## Lexington Trace 2 SWPPP Approval Issues

Image 1-5-23 at 11.06 AM.jpeg  
252K

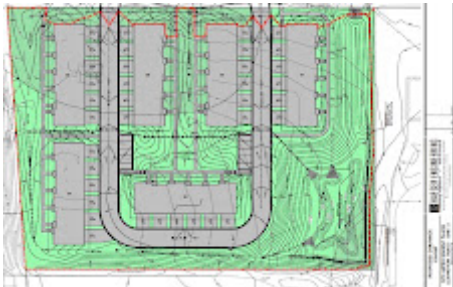
Here is the drainage plan for the site. See all the arrows leaving the driveways? The water will move that way with gravity. If all the curbs are flat, which they are, a curbside BMP would be necessary until that area is stabilized. Or you get all the sediment laden water/pollutants going into the existing inlets, and retention pond which has not been seeded to filter via infiltration. This plan should never have been approved.
